SUBJECT: Rio Mesa Solar (11-AFC-04) - Applicant's Comments on Preliminary Staff Assessment

***APPLICATION FOR CERTIFICATION FOR THE
RIO MESA SOLAR ELECTRIC
GENERATING FACILITY***

Figure 1 – Several Major Population Centers in Relation to Project Power Towers

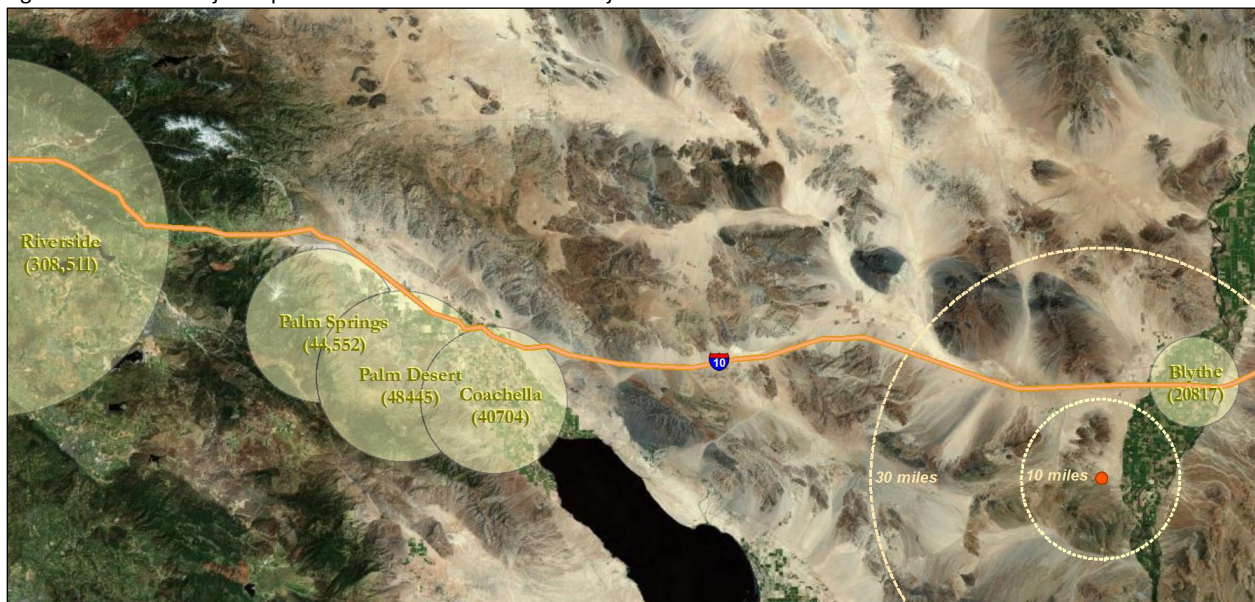
The PSA identifies sensitive viewers within the Palo Verde Valley as residents in around Palo Verde and Ripley and motorists on SR-78.
